RESOLUTION NO. 2016-26

**A RESOLUTION APPROVING THE WINTER AND
COMPANY ANALYSIS AND TESTING OF PROPOSED
DEVELOPMENT CODE REPORT**

DRAFT ZONING CODE ANALYSIS AND TESTING

Columbia, Missouri

FULL-BLOCK TEST:

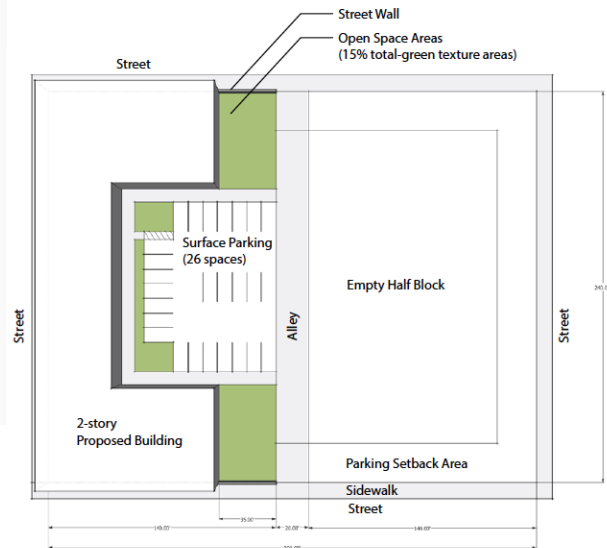
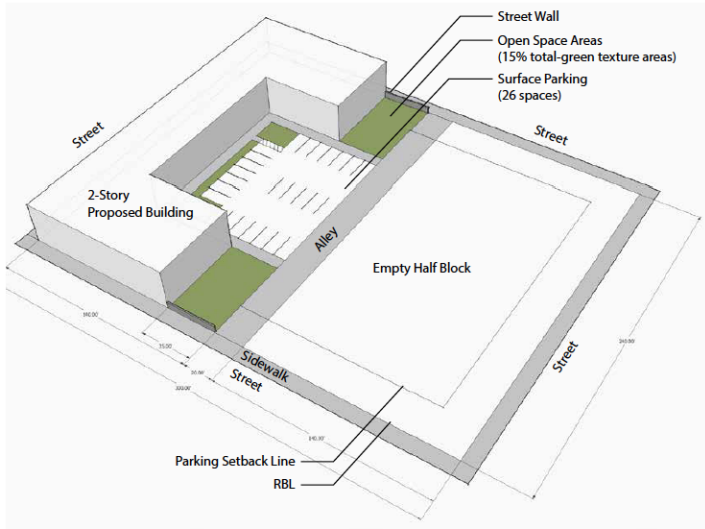
This examines the implications of a phased approach to developing a full city block. In this case, a new 2-story building is shown, which meets the building and site requirements, as we interpret the FBC. Each building face extends to 75% of the lot dimension. Surface parking is maximized for the remaining area of the site, within the code's requirements to provide a parking setback and street wall.

HALF-BLOCK TEST:

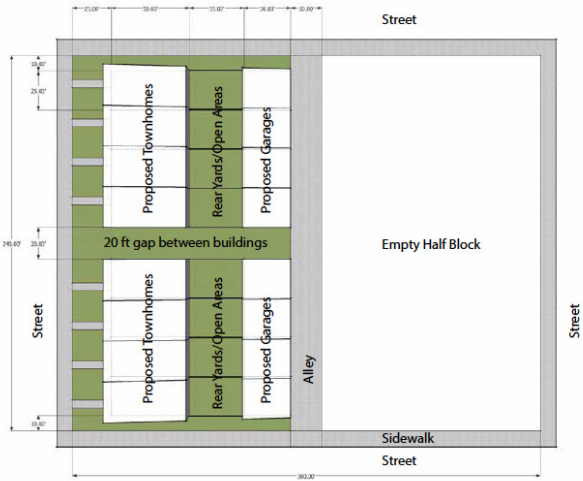
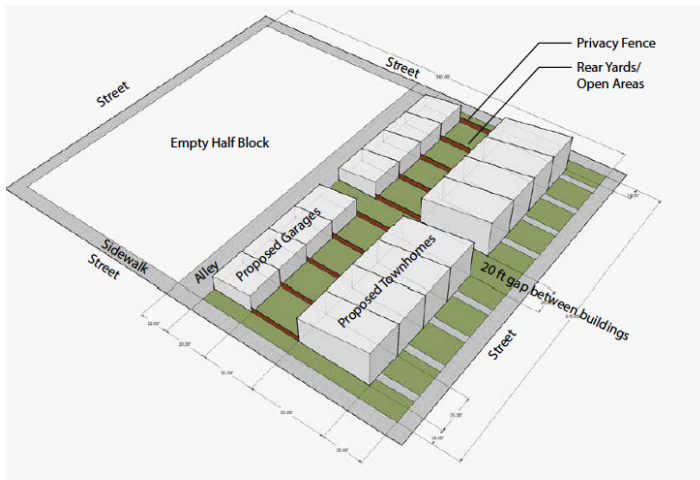
- **Parking setback area** - creates a setback condition that is not useful for development needs
- **Open area requirement** - limited to prime site area due to provisions and parking setback area
- **Street wall requirement** - no issues anticipated beyond clarity of fenestration and measurement
- **Curb cuts/Street access** - no issues anticipated
- **Maximum development area** - no issues anticipated
- **Facade Articulation & Fenestration** - no issues anticipated beyond clarity of code provision
- **Required Build-To Line** - no issues anticipated beyond the need to clarify the 75% code provision

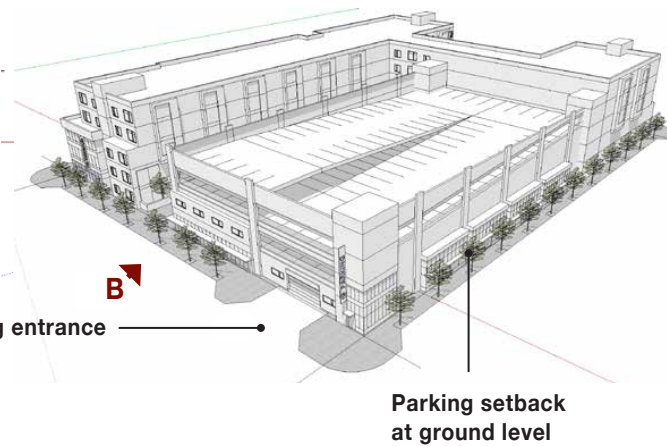
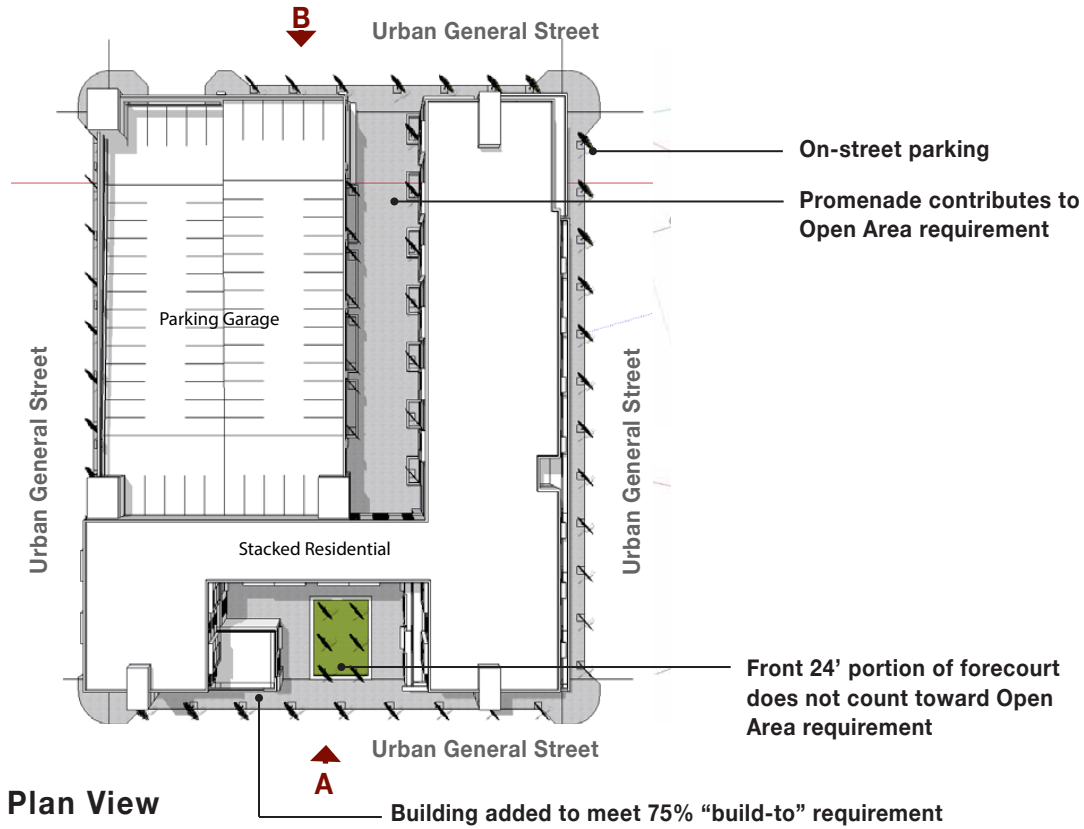
- **Parking setback area** - reduces the parking capacity by approximately 30 spaces on the ground floor
- **Open area requirement** - developed on ground floor, balconies, and roof to adhere to requirement
- **Street wall requirement** - feature not necessary in this project
- **Curb cuts/Street access** - no issues anticipated for this code provision
- **Maximum development area** - no issues anticipated for this code provision since parking garages do not count against the total
- **Facade articulation & Fenestration** - no issues anticipated beyond clarity of code provision
- **Required Build-To Line** - requires project to add “bump in “ to adhere to forecourt requirements

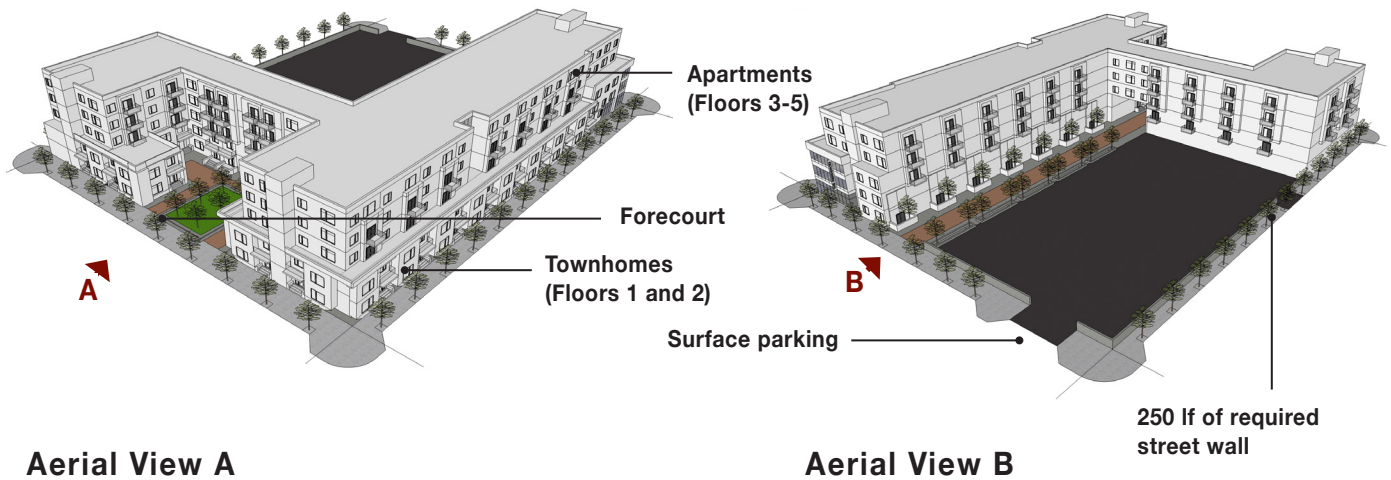
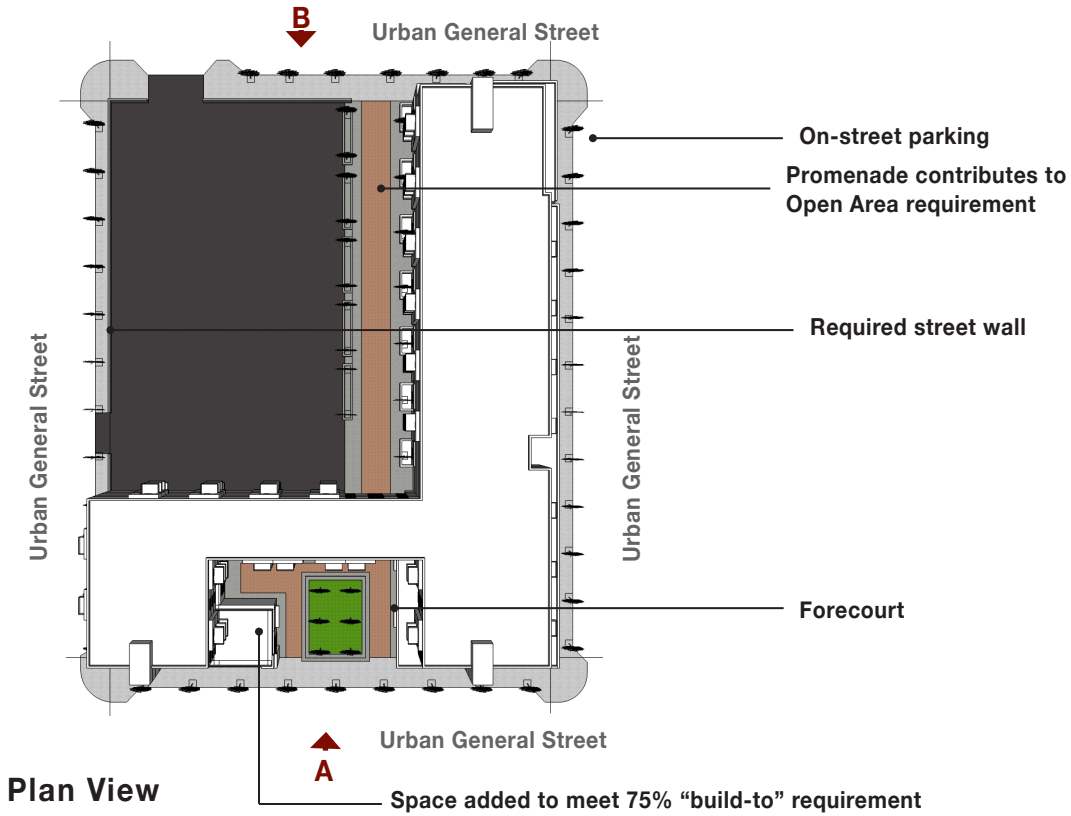
- **Parking setback area** - does not currently conform to this requirement, but would reduce the parking capacity by approximately 30 spaces
- **Open area requirement** - provided on ground floor, balconies, and roof to adhere to requirement
- **Street wall requirement** - application of this requirement is unclear in language of code
- **Curb cuts/Street access** - no issues anticipated for this code provision
- **Maximum development area** - no issues anticipated
- **Facade articulation & Fenestration** - no issues anticipated beyond clarity of code provision
- **Required Build-To Line** - requires project to add “bump in “ to adhere to 75% “build-to” requirement

- This scenario is the most feasible of the Case Study #1 different scenarios
- Add ground story ‘bump in’ to adhere to forecourt requirements
- Project is non-conforming due to the lack of a parking setback area for the parking lot

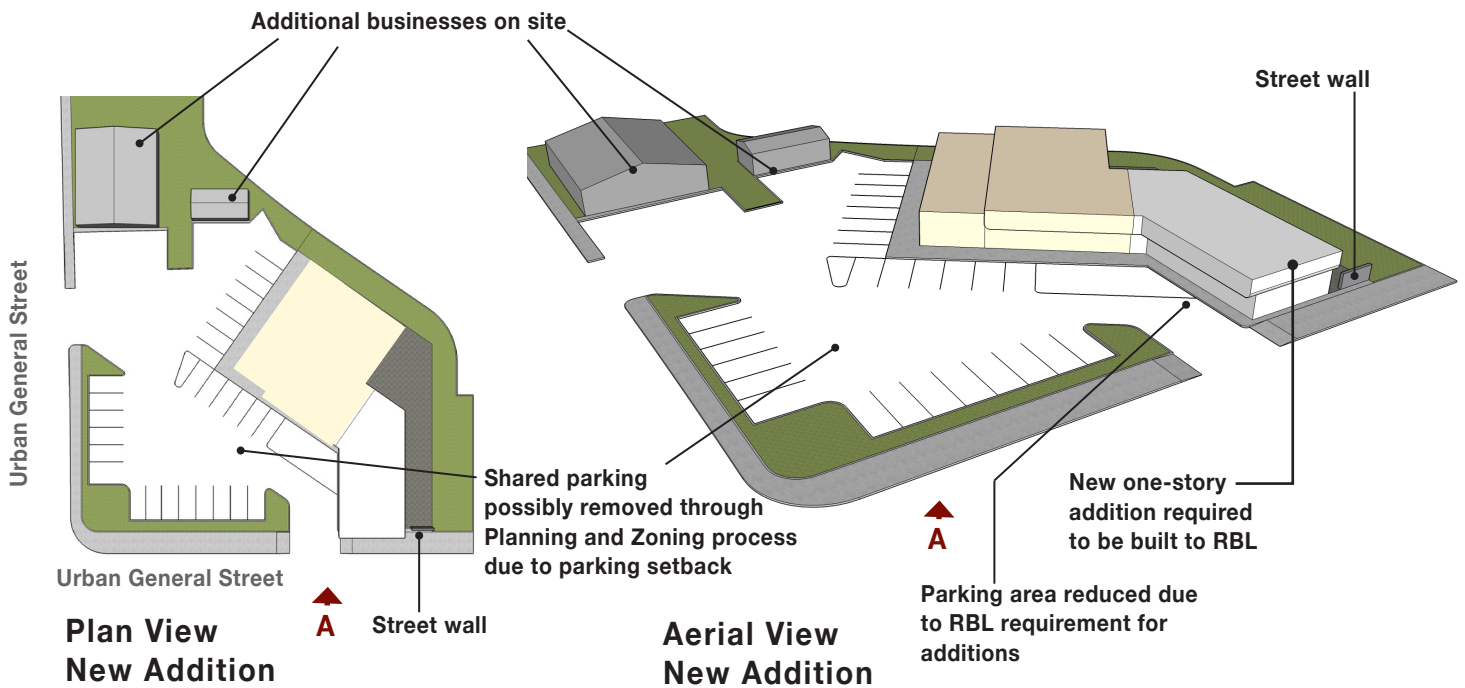
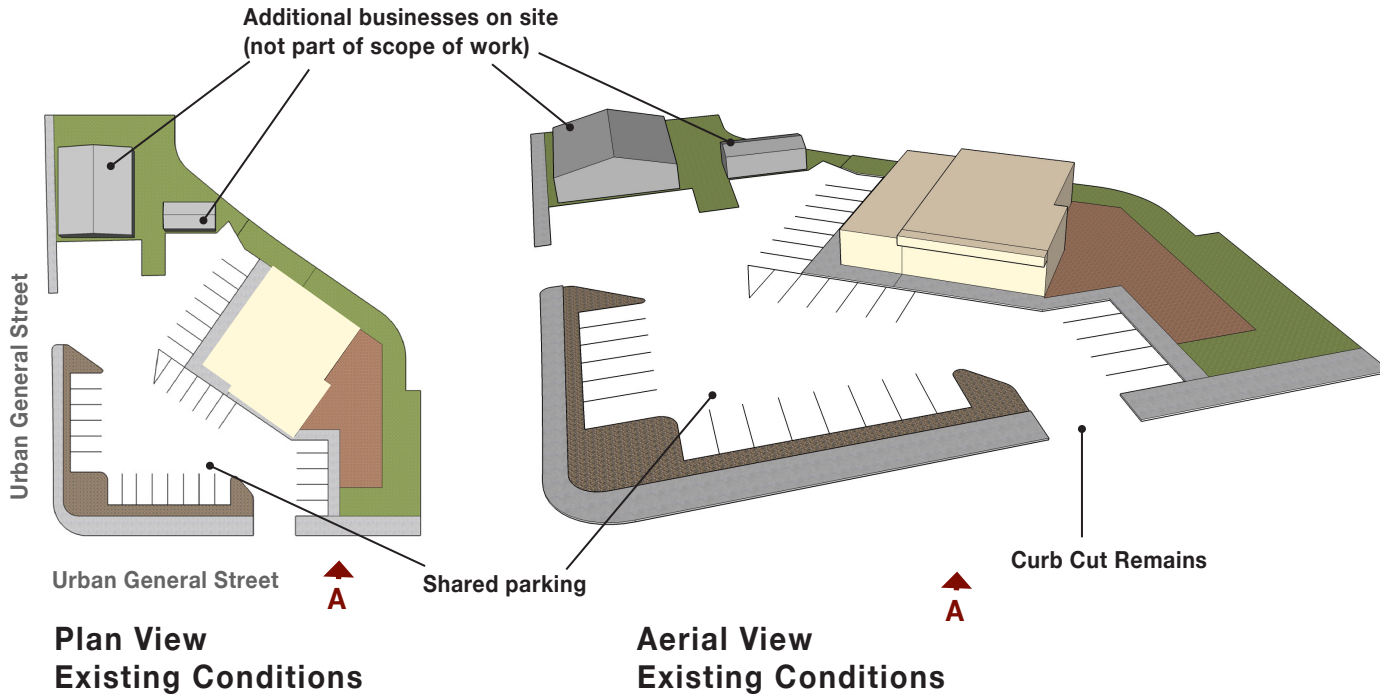
- **Parking setback area** - applicability for this provision is unclear due to site conformity requirements with addition. If site conformities are required, 16 spaces will be removed at corner interior.
- **Open area requirement** - no issues anticipated
- **Street wall requirement** - applicability for this provision is unclear due to site conformity requirements with addition. If site conformities are required, 200' of street wall would be added at RBL around corner.
- **Curb cuts/Street access** - no issues anticipated
- **Maximum development area** - no issues anticipated
- **Facade articulation & Fenestration** - no issues anticipated beyond clarity of code provision
- **Required Build-To Line** - requires addition to be built to sidewalk edge

- Project is not financially feasible
- The addition meets the Required Build-to Line (RBL), but does not meet owner's functional requirements
- Questions regarding whole site compliance vs. specific addition compliance still remain
- Parking setback requirements may eliminate over half of the on site parking (16 spaces)

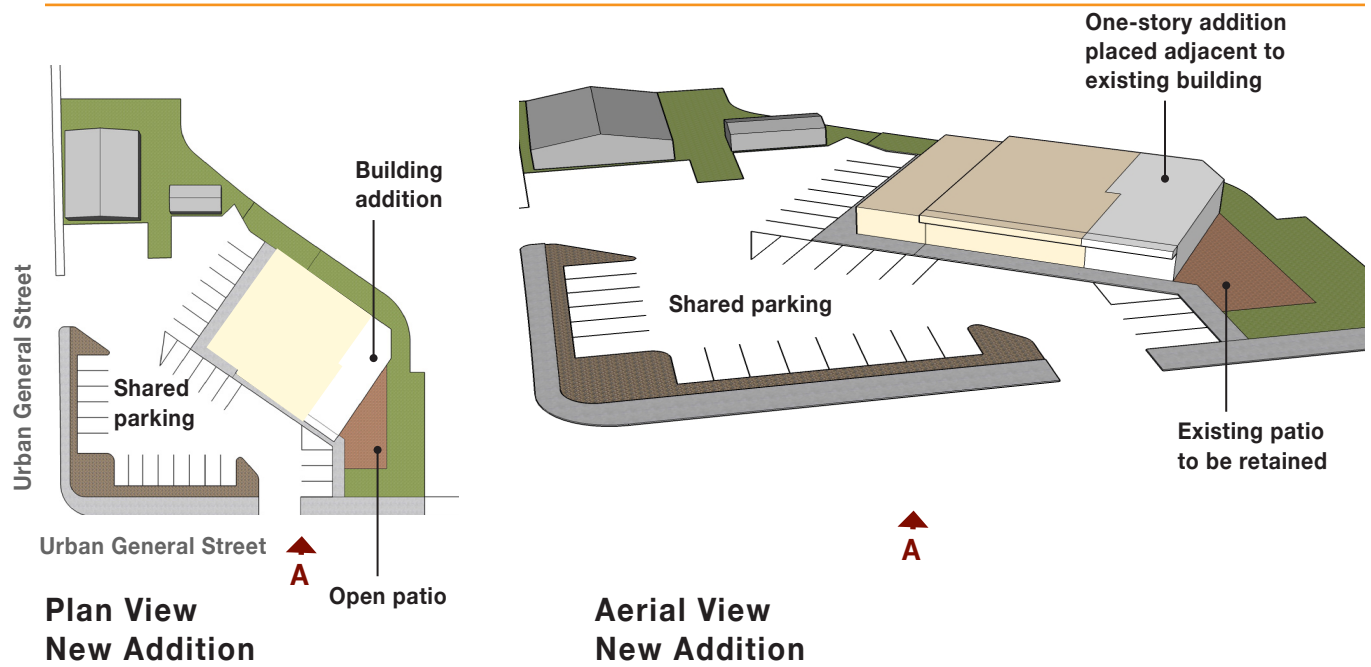
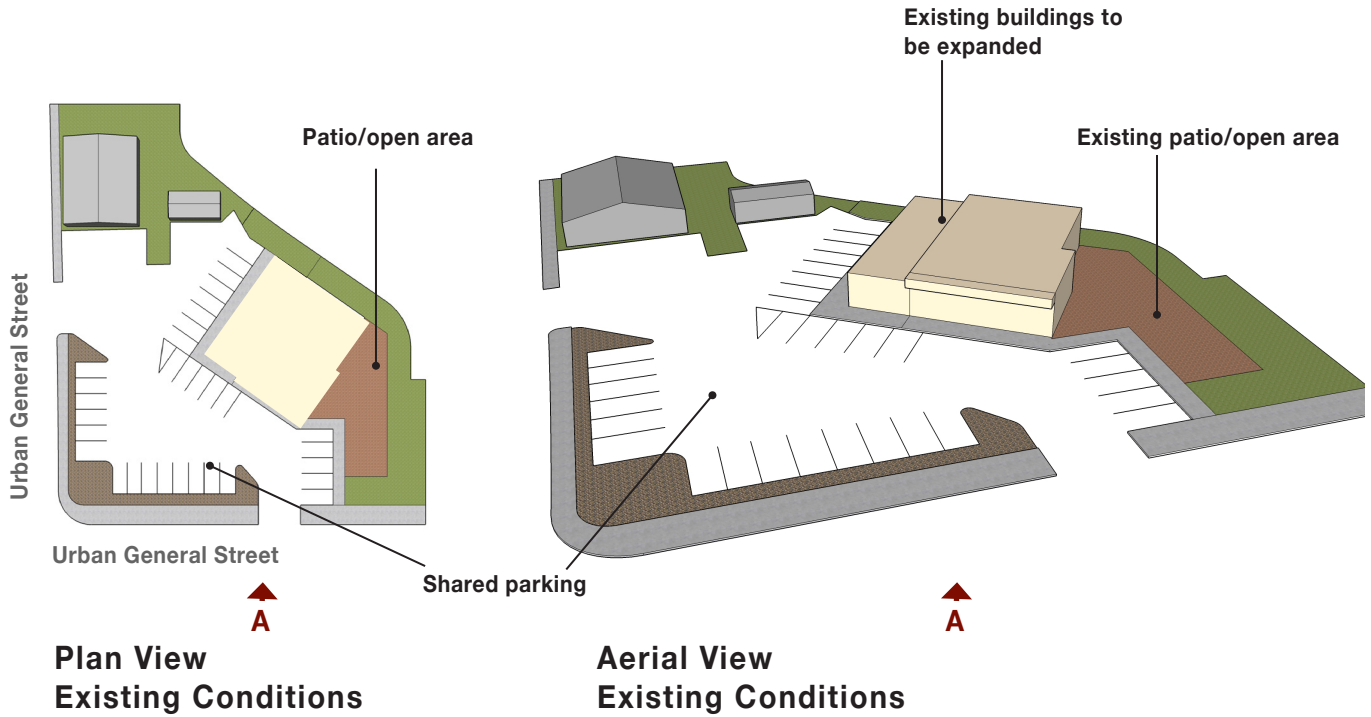
- **Parking setback area** - applicability for this provision is unclear due to site conformity requirements with addition. If site conformities are required, 16 spaces will be removed at corner interior.
- **Open area requirement** - no issues anticipated
- **Street wall requirement** - applicability for this provision is unclear due to site conformity requirements with addition. If site conformities are required, 230' of street wall would be added at RBL around corner.
- **Curb cuts/Street access** - no issues anticipated
- **Maximum development area** - no issues anticipated
- **Facade articulation & Fenestration** - no issues anticipated beyond clarity of code provision
- **Required Build-To Line** - this scenario does not have an addition that is built to the RBL

- Project is financially feasible when the building addition and necessary site work are considered in financial analysis and no other site work for open area or landscaping is included
- Preferred project addition is challenged by Required Build to Line (RBL)
- Questions regarding whole site compliance vs. specific addition compliance
- Parking setback requirements eliminate over half of the onsite parking (16 spaces)
- Existing patio area is retained and reused

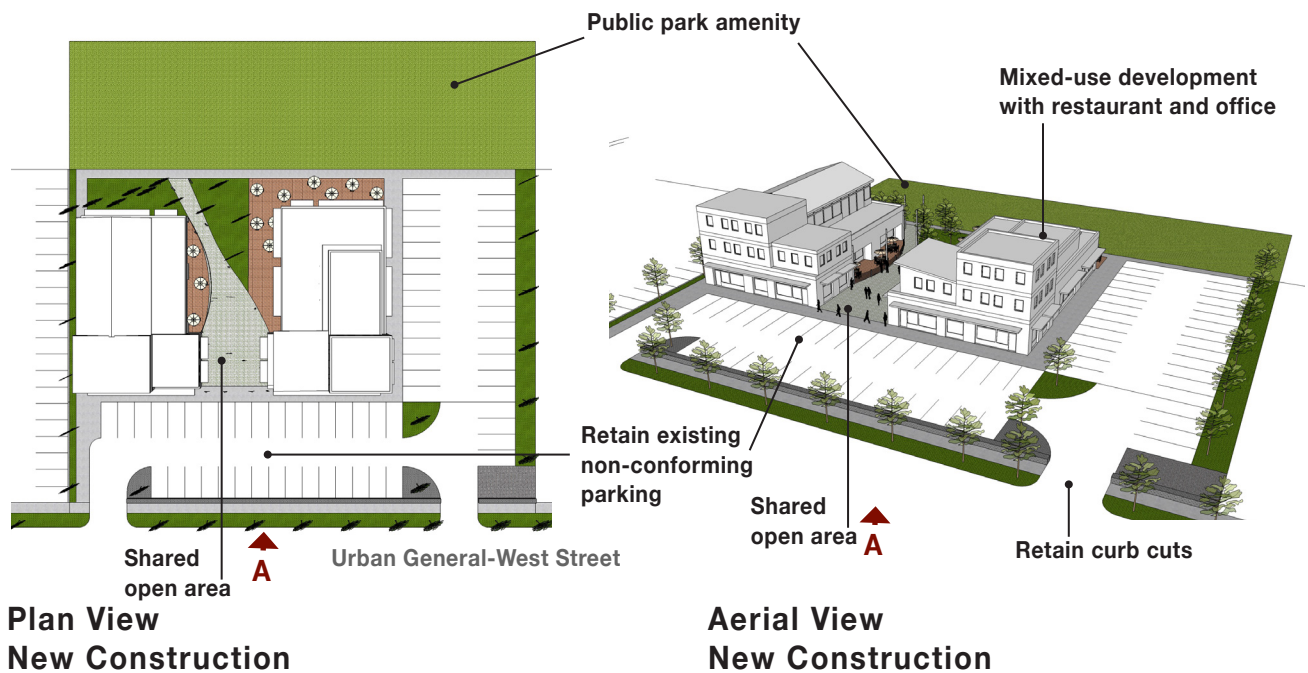
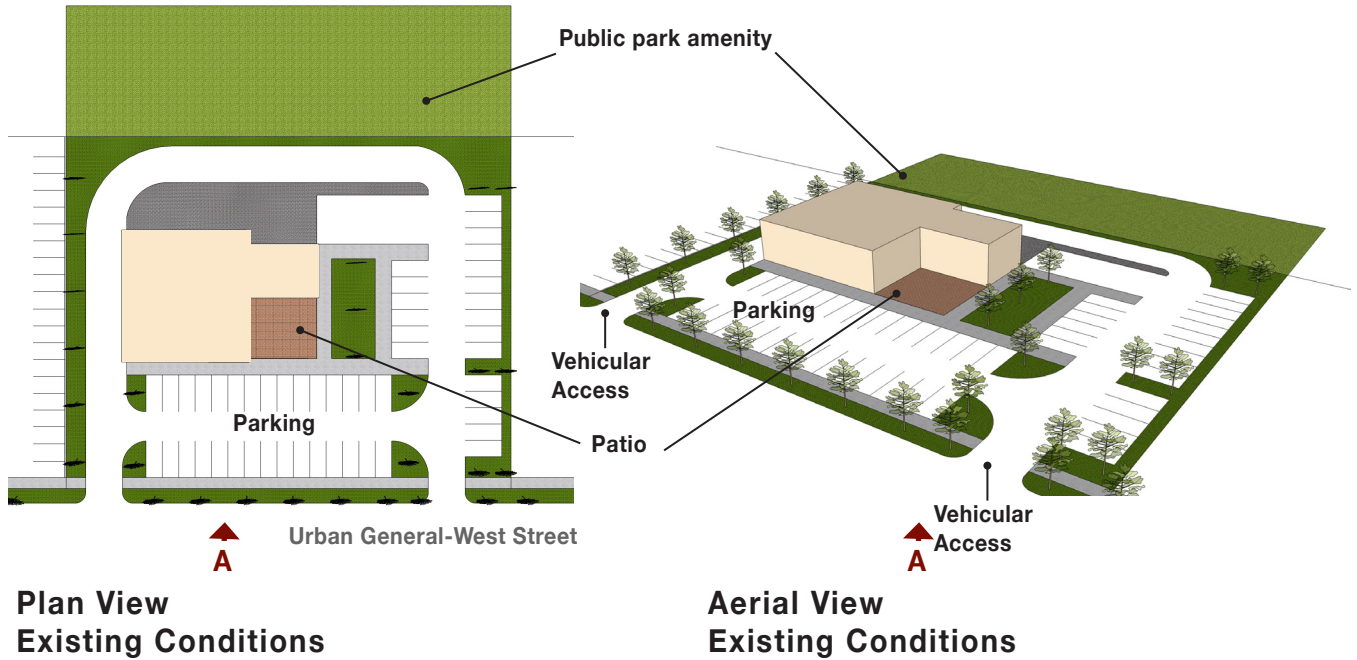
- **Parking setback area** - parking layout does not conform to this code provision
- **Open area requirement** - no issues anticipated
- **Street wall requirement** - no issues anticipated
- **Curb cuts/Street access** - no issues anticipated
- **Maximum development area** - no issues anticipated
- **Facade articulation & Fenestration** - no issues anticipated beyond clarity of code provision
- **Required Build-To Line** - new development does not conform to this code provision
